2.5.4 Stability of Subsurface Materials and Foundations

**Figure 2.5.4-9 - Allowable Bearing Capacity of Typical Foundations
 (Reproduced from SSAR Figure 2.5.4-13)**

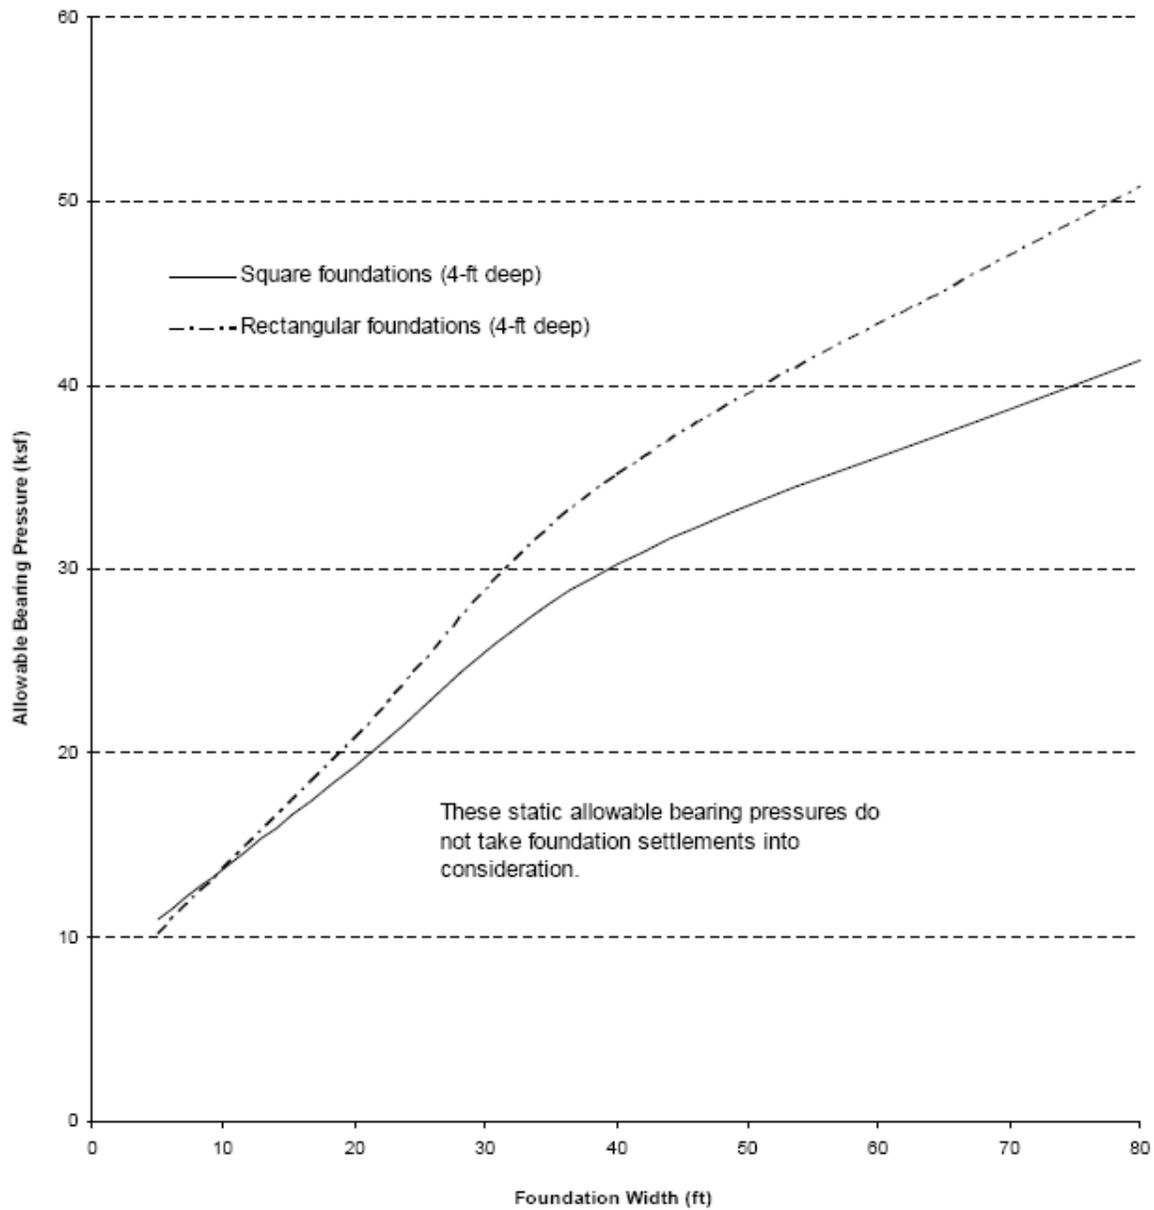
In RAI 2.5.4-18, the staff asked the applicant to provide detailed information on its determination of the allowable bearing capacity value. In its response, the applicant provided a detailed description of bearing capacity evaluations based on the Vesic (1975) formula. In addition, the applicant later clarified that the calculated value was net allowable bearing capacity, not the gross bearing capacity; therefore, the formula used in the actual calculation was slightly different from that presented in the reference. From its review of the applicant's response, the staff considers that the Vesic (1975) formula is based on primary assumptions of gross shear failure of soils under the foundation. Although this allowable bearing capacity formulation is applicable for general foundation analysis, it is inappropriate to use it in nuclear power plant foundation design. The control factors of allowable contact pressure for a large and heavy structure typically are not general shear failure but are (1) settlements; (2) allowable pressures used in design of the wall/basemat intersection; and (3) toe pressures developed during potential overturning and sliding of the facility. Based on the above considerations, the staff concludes that the allowable bearing capacity value provided by the applicant is not appropriate when considering the expected governing issues controlling the site evaluation. This is **Open Item 2.5-22**.

4. The applicant used some general methods in its calculations and analyses without thoroughly examining all important factors and considering all possible scenarios. For example, the applicant used the Vesic (1975) formula to determine the allowable bearing capacity of the bearing stratum. Since the formulation was based on primary assumptions of gross shear failure of soils under the foundation, it is applicable for general foundation analysis, but not appropriate for use in nuclear power plant foundation design because the typical control factors of the allowable contact pressure for such large and heavy structures are settlements, allowable pressures that are used in the design of the wall/basemat intersection, and toe pressures developed during potential overturning and sliding of the facility.

**Figure 2.5.4-10 - Settlement of Typical Foundation
(Reproduced from SSAR Figure 2.5.4-14)**

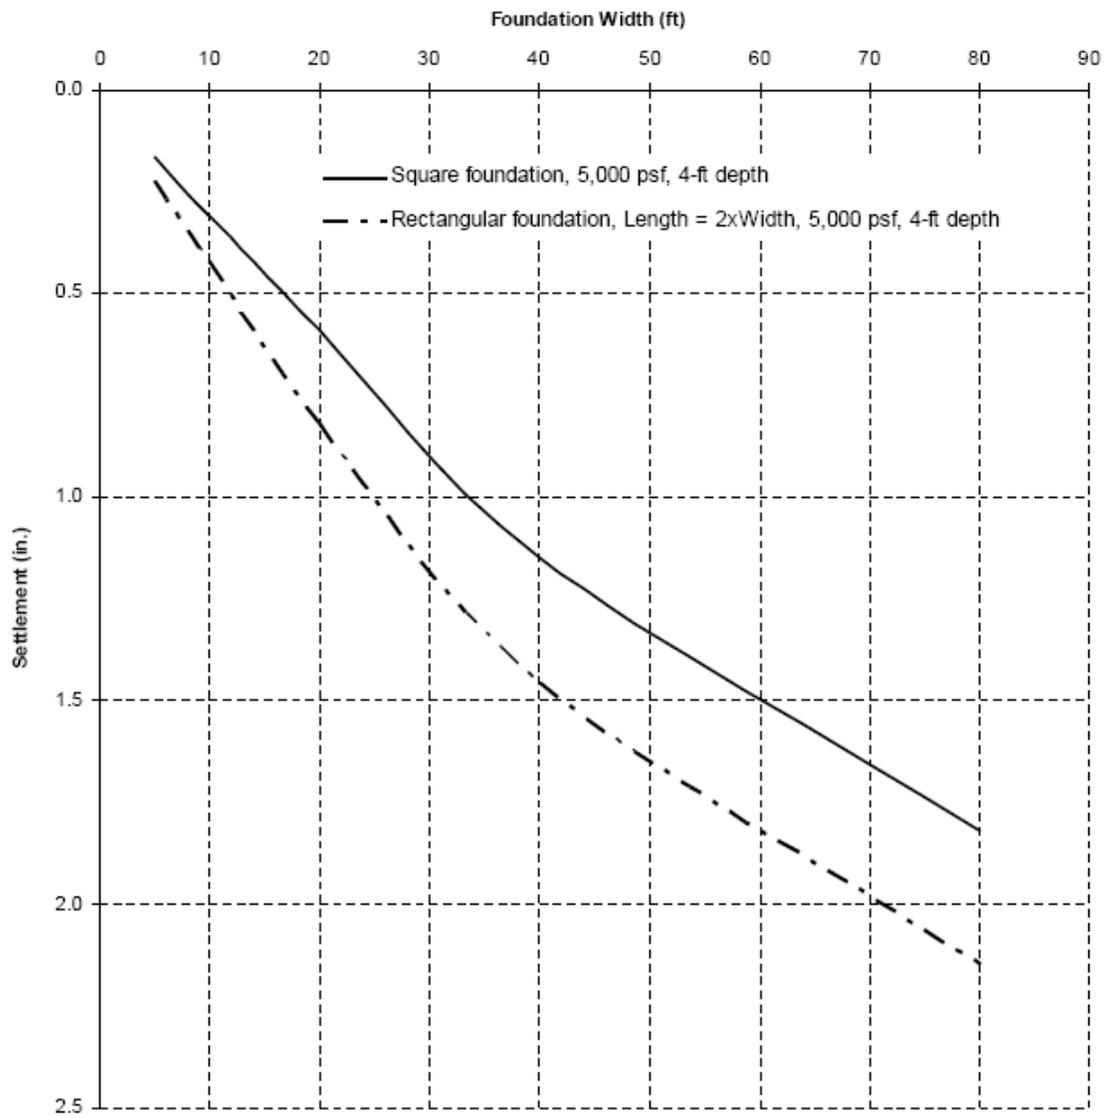
1. Justify the adoption of the Peck et al. (1974) settlement and differential settlement values as guidelines which suggest total settlement of no more than 50 mm (2 in.), and differential settlement of no more than 19 mm (0.75 in.). For footings that support smaller plant components, the total settlement should be no more than 25 mm (1 in.), and the differential settlement no more than 13 mm (.5 in.).

1. A primary concern of potential total and differential settlements is how these settlements compare with what the design of the reactor takes into consideration. It is important to compare the estimated settlements, which are appropriate for evaluation of the acceptability of the site at the ESP stage, with those incorporated into the plant design to evaluate the degree of conservatism because there will be severe impact to the safety of the SSCs once unexpected differential settlements occur.
2. The contact pressures associated with the planned reactor model are of interest and need to be considered at the ESP stage to estimate potential settlement. Since the data for a given reactor facility are available, the applicant should incorporate it into the site evaluation.

3. It (the applicant) used a bearing pressure value of 239.5 kPa (50000 psf) in foundation settlement analysis for illustrative purposes because no design value was available during the ESP. The applicant will revise the calculation using design values during the COL application.
